# Chestnut Hill Avenue

## Responses to Transportation Board Feedback

Brookline Transportation Board Meeting

September 16, 2026

# Cross-Section – South of Ackers Avenue

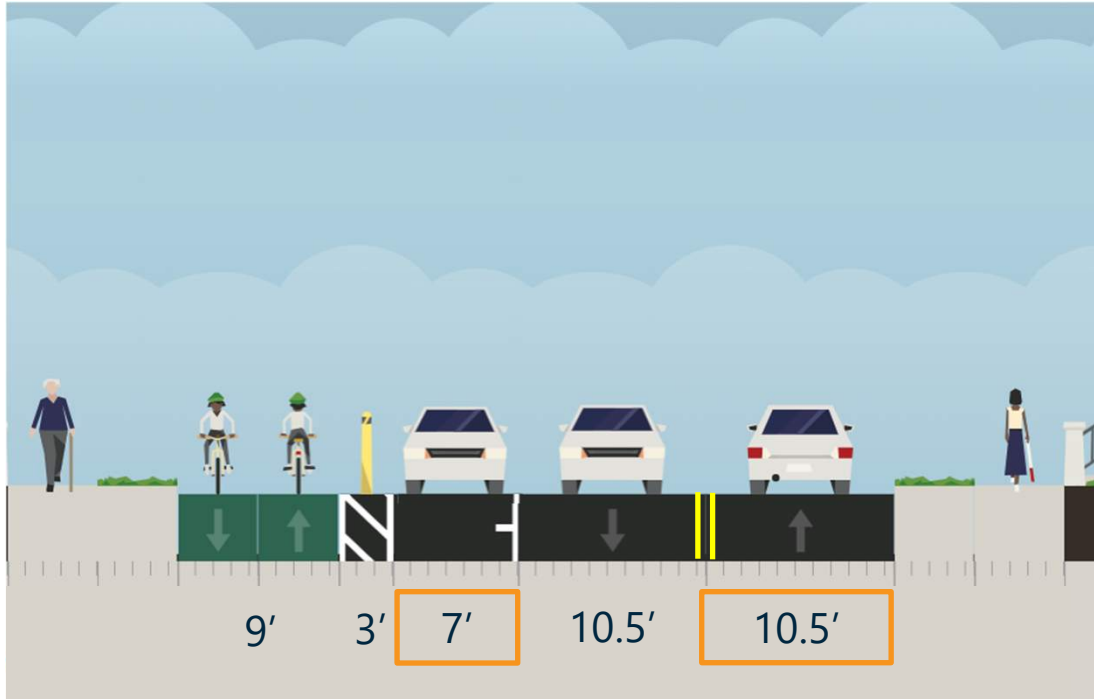
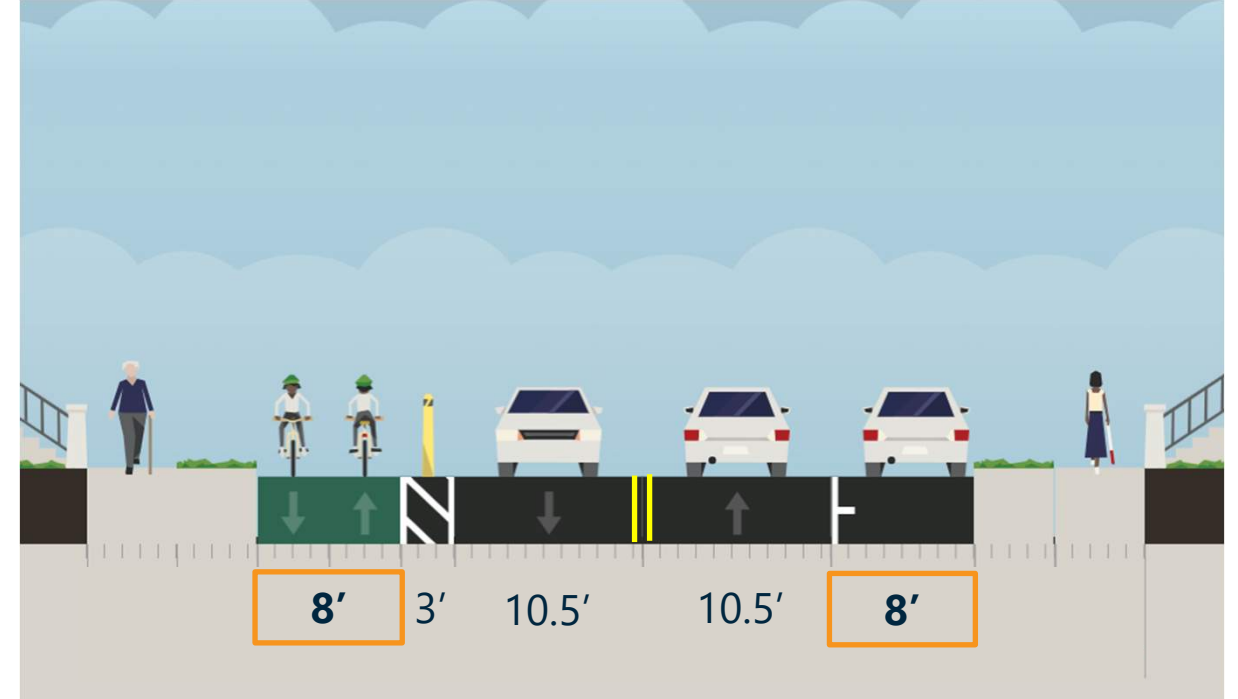
- Parking relocated from southbound to northbound side
- Parking lane increased from 7 feet to 8 feet
- Cycle track reduced from 9 feet to 8 feet

# Parking and Pedestrian Access South of Ackers Avenue

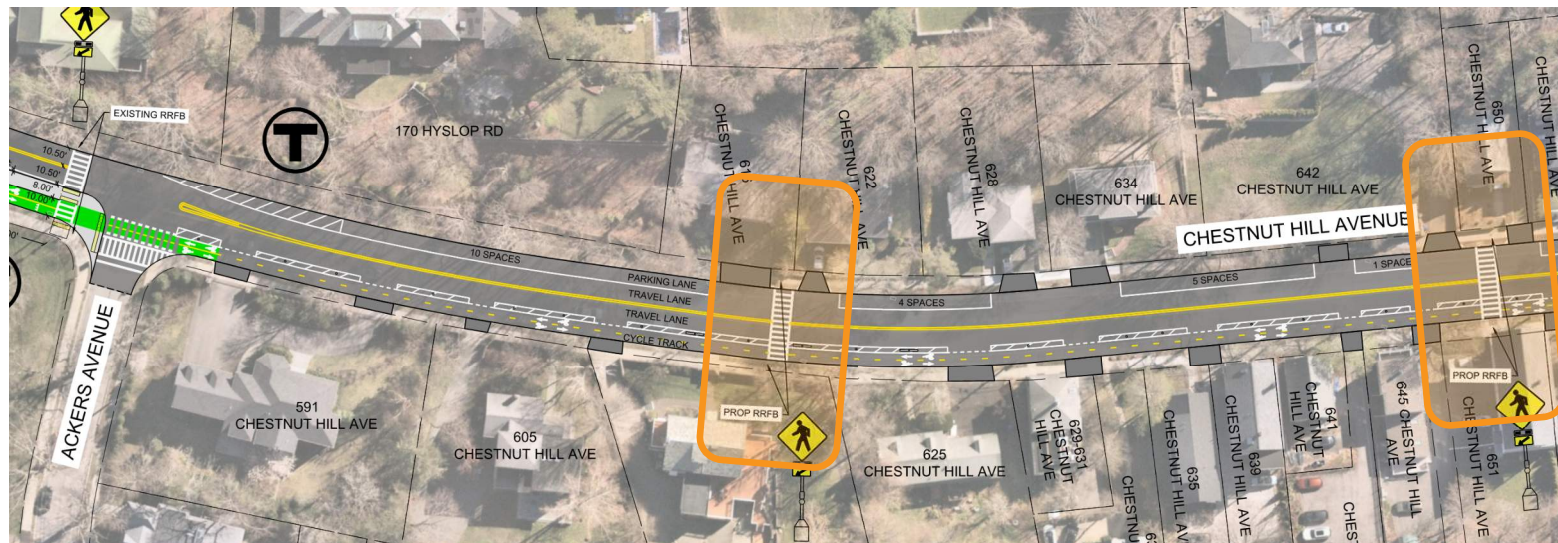
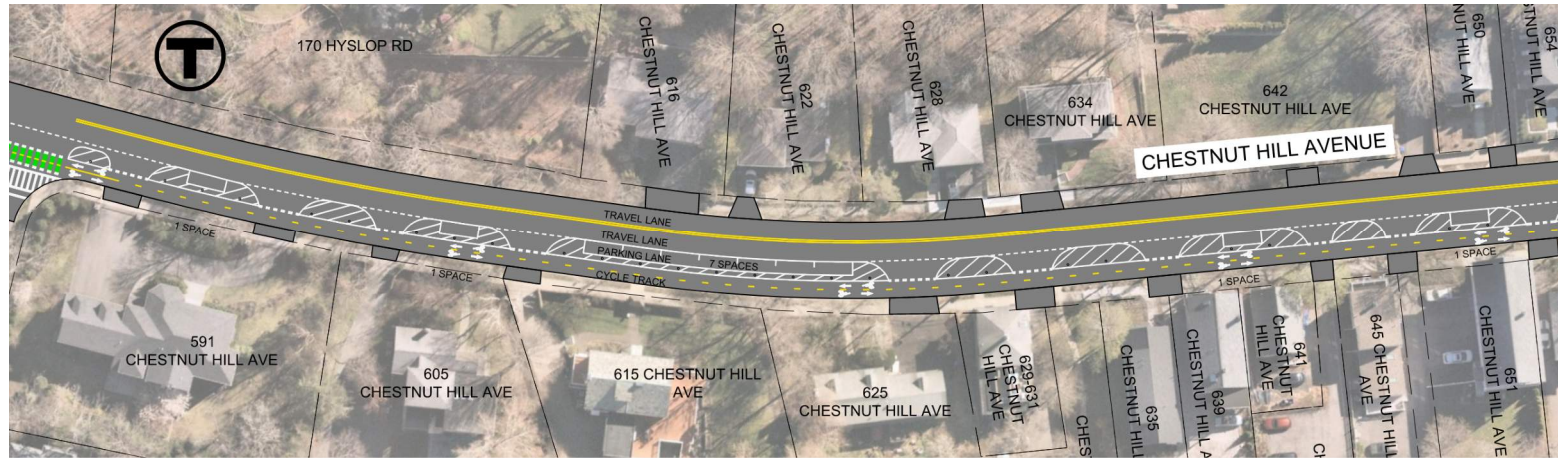
- Parking increases from 15 to 32 spaces south of Ackers Avenue
- Two additional pedestrian crossings shown conceptually
- Crossing locations and treatments to be refined
- Updated corridor-wide parking total for Option C: **65 spaces**

# Cross-Section – North of Ackers Avenue

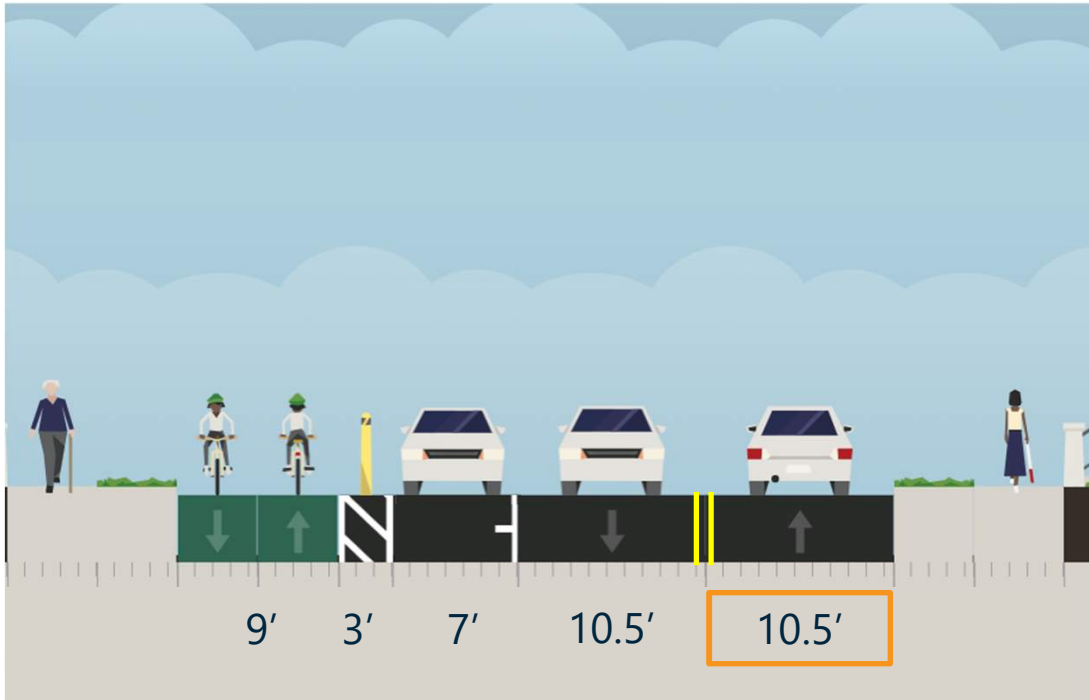
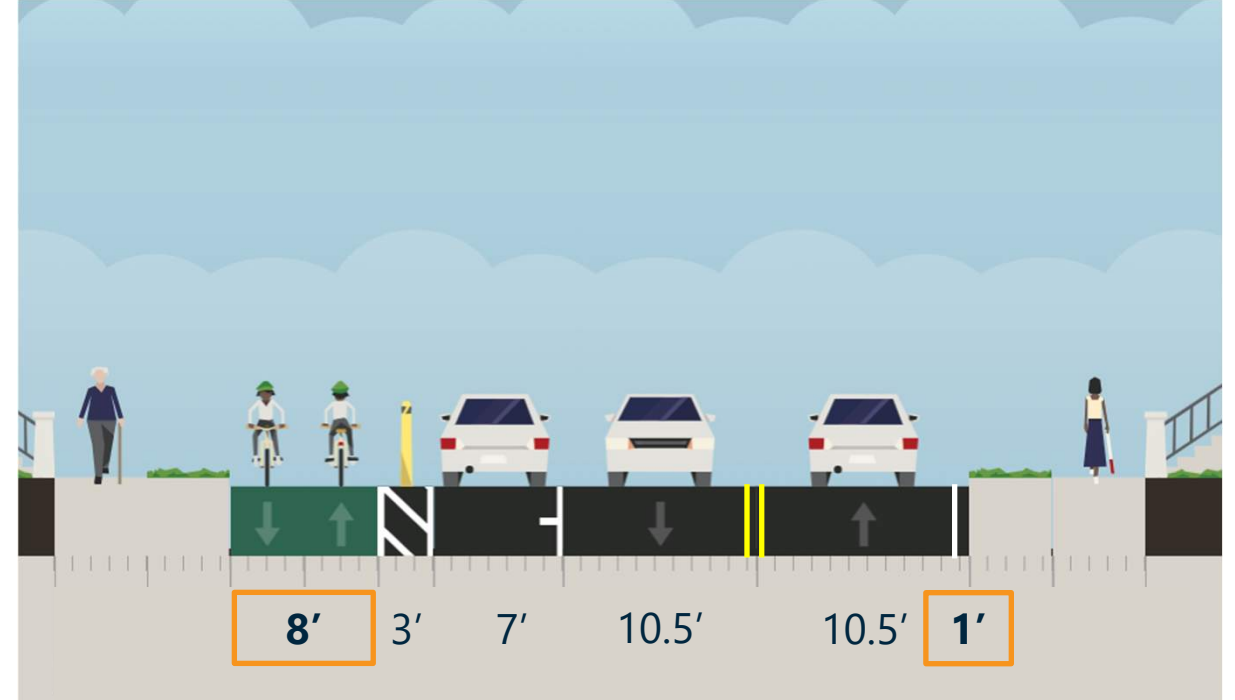
- Cycle track width reduced from 9 feet to 8 feet
- 1-foot northbound shoulder added

# Ackers Avenue to Buckminster Road

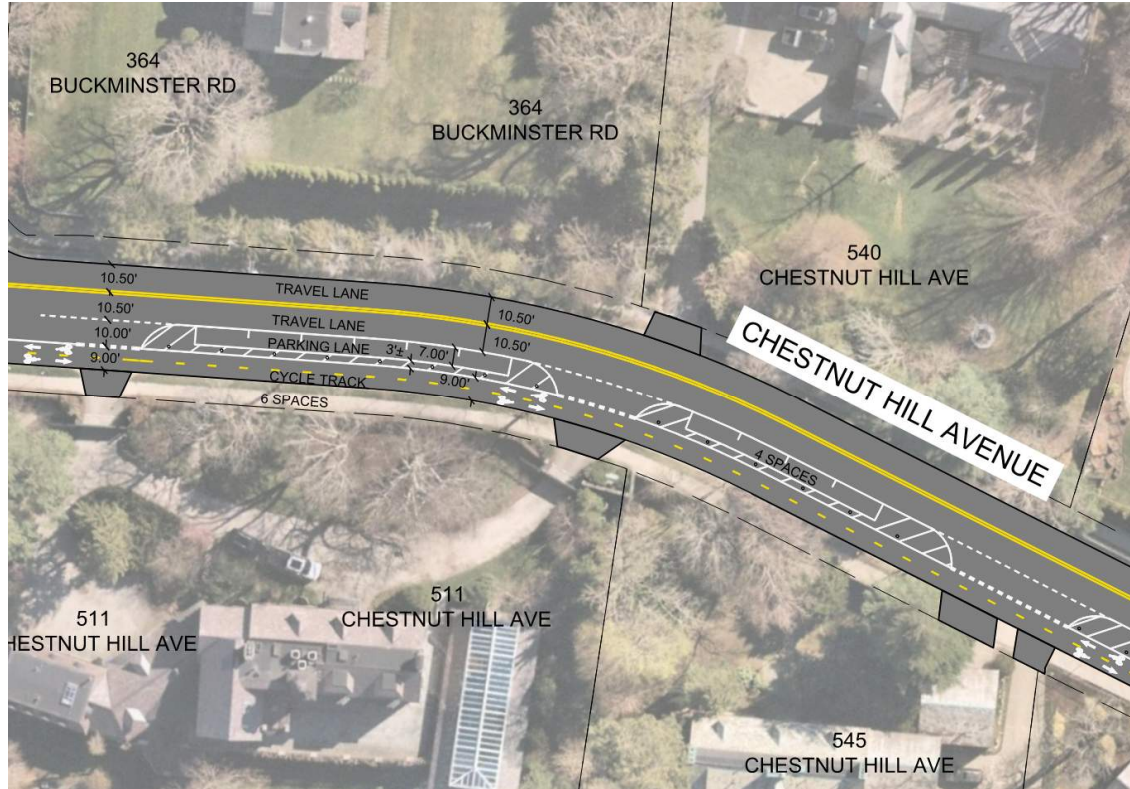
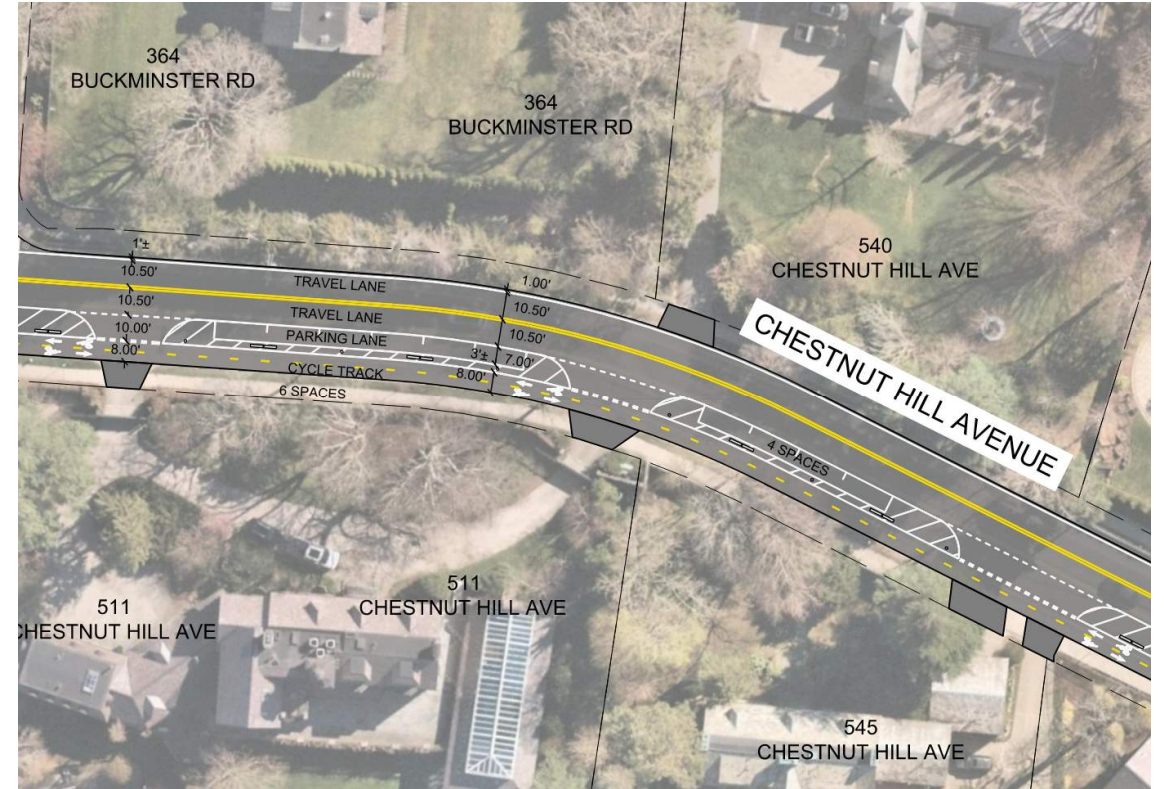
- Shoulder added to northbound side
- Cycle track reduced from 9' to 8'

# Cross-Section – Willard Rd to Dean Rd

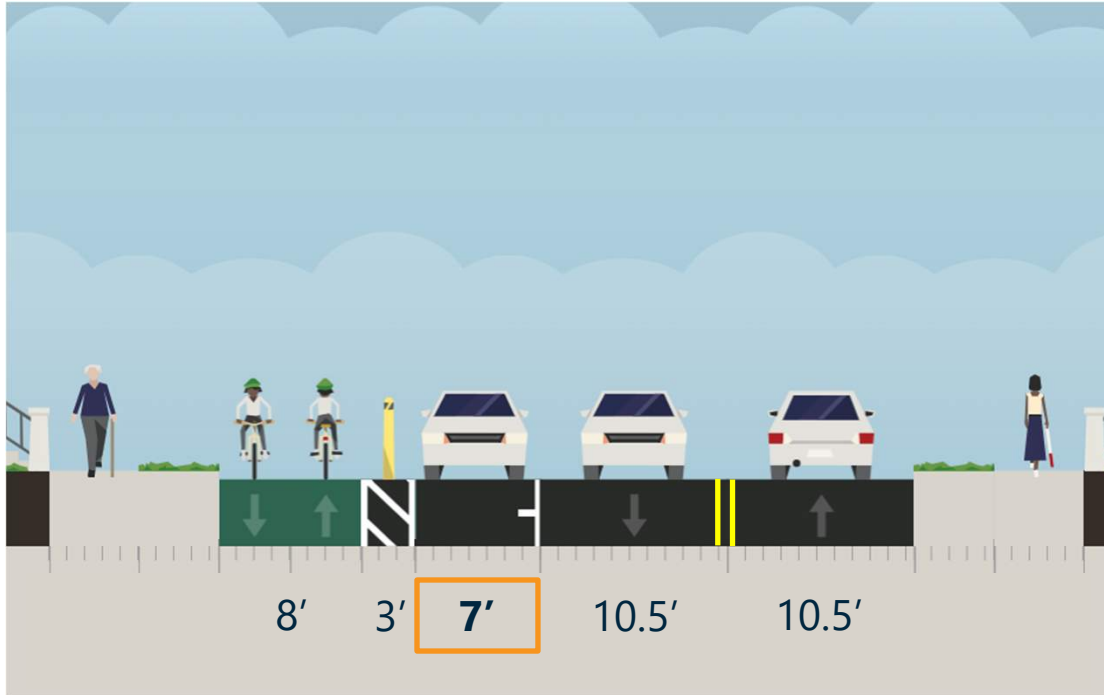
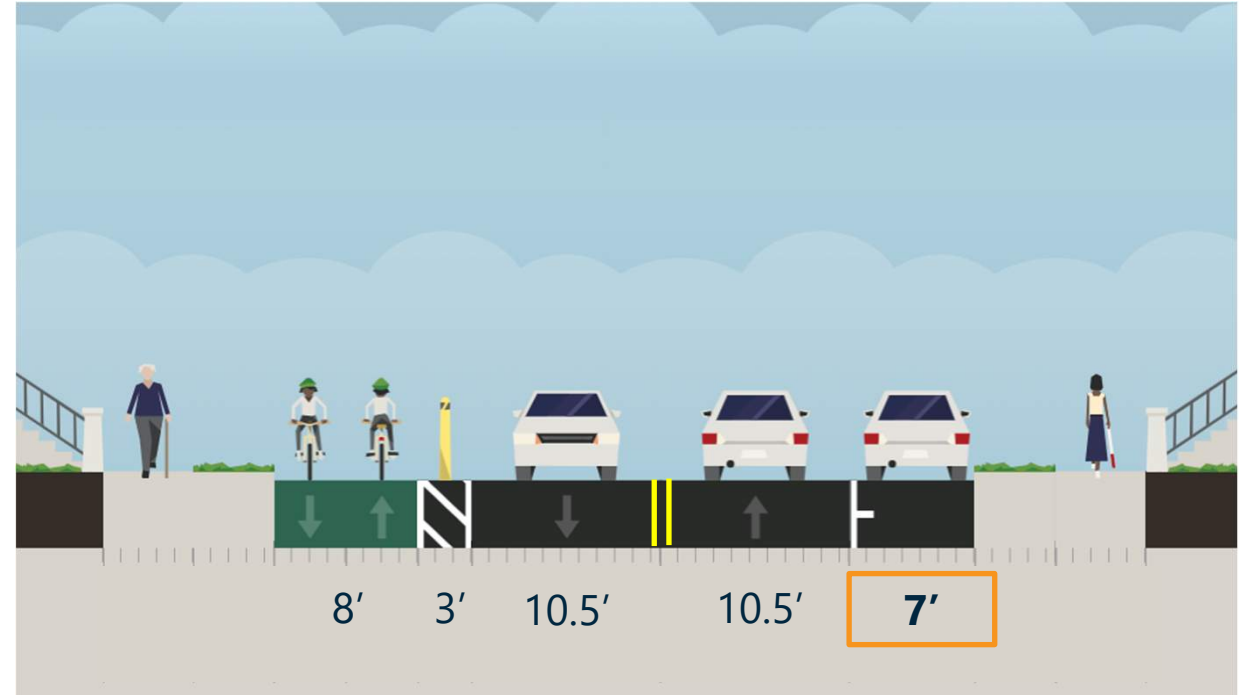
- Parking shifted to northbound side

# Dean Road to Willard Road

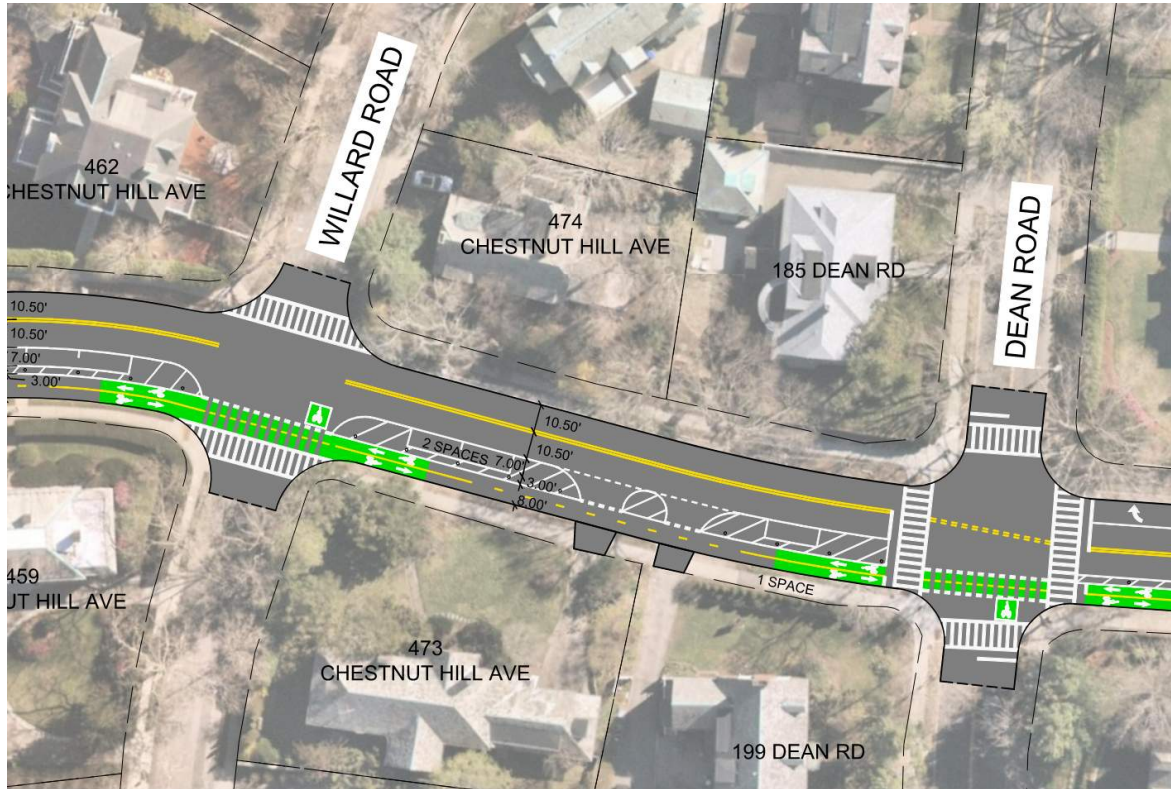
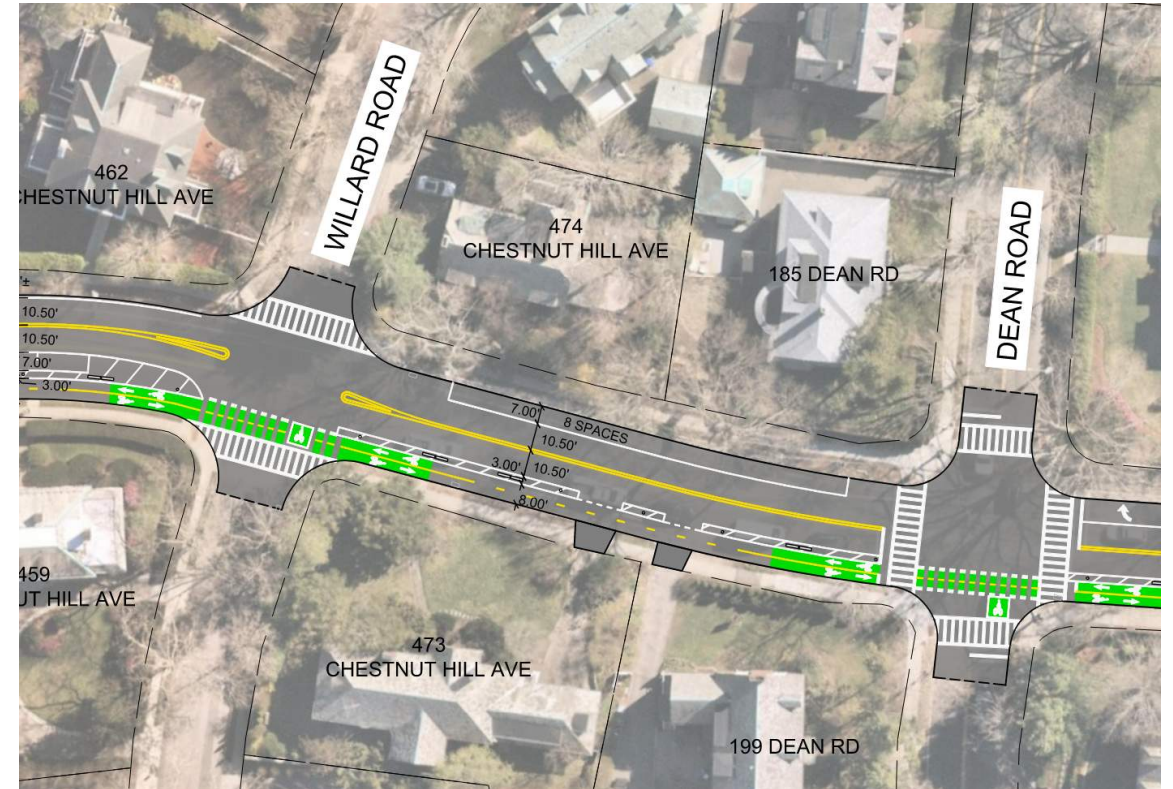
- Parking shifted to northbound side
- 4 parking spaces added between Clinton Road and Dean Road
